Northland Corridor Redevelopment Project Phase 3: Questions And Answers
Through Addendum 3

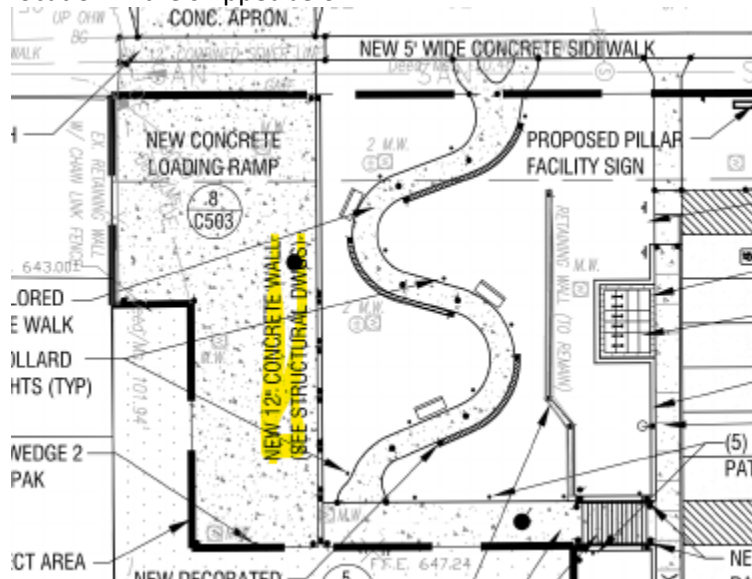
111. Q: Drawing A600 of the 612 Northland Ave. drawings denotes the overhead doors (type OHD) as insulated metal overhead doors and references spec section 083613. Please provide this spec section as there is not currently this section in the project manual. Also confirm that they are insulated metal as the door schedule (same drawing) calls them to be aluminum & glass with an anodized finish.

**A: • Reference spec 083613 for sectional overhead doors.
• They are insulated metal as indicated on door schedule.**

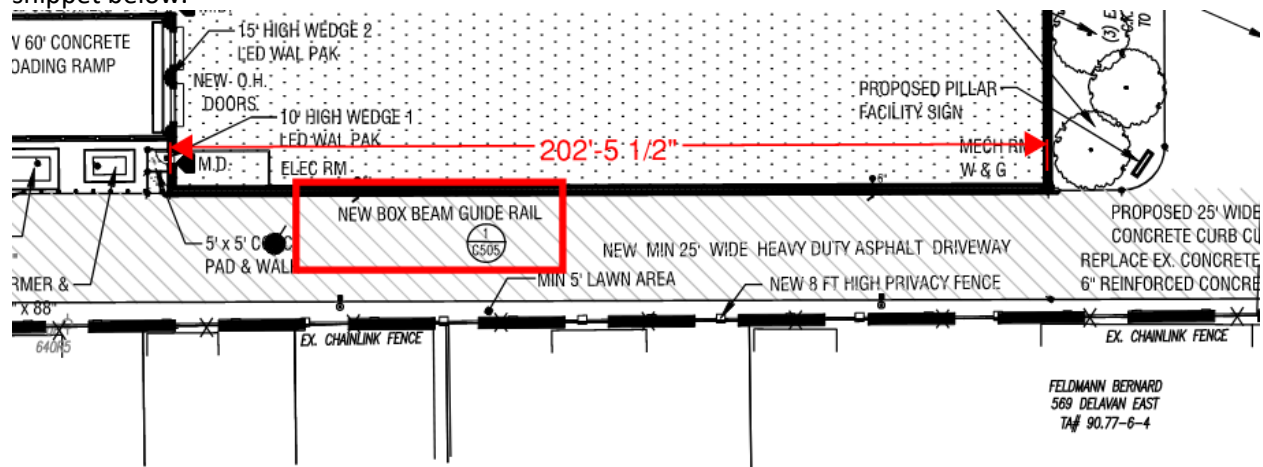
113. Q: C201 Site plan for 612 Northland Ave. shows a "New 12" Concrete Wall (See structural drawings)". I'm not sure I could find it in the drawings. Could you please provide the details for this wall or clarify if it is similar to the loading ramp wall in the base bid (detail C504-8). I'm referring to the location in the snippet below.

A: Wall detail for decorative steel structure to be provided during construction upon receipt of steel artwork shop drawing.

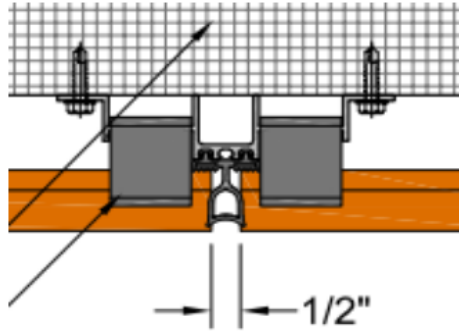
Assuming this question is for TC02:

- Both panels and baguettes are to be the same color. reference updated exterior finish material schedule and detail on A200. A201, A202, and A203.
- TC02
 - Clay color: tan B104.A
 - Glaze color: custom (to be coordinated with by Boston Valley)

TULIP GASKET JOINT

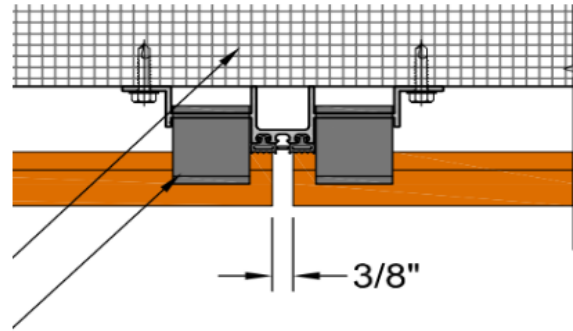
3. Please confirm which vertical joint is desired at the main fields of Horizontal Terra Cotta Panels. Tulip gaskets incur additional costs. In either scenario will a standard black gasket be acceptable?

A: Response: The standard gasket joint shown will be acceptable. and yes, in black.
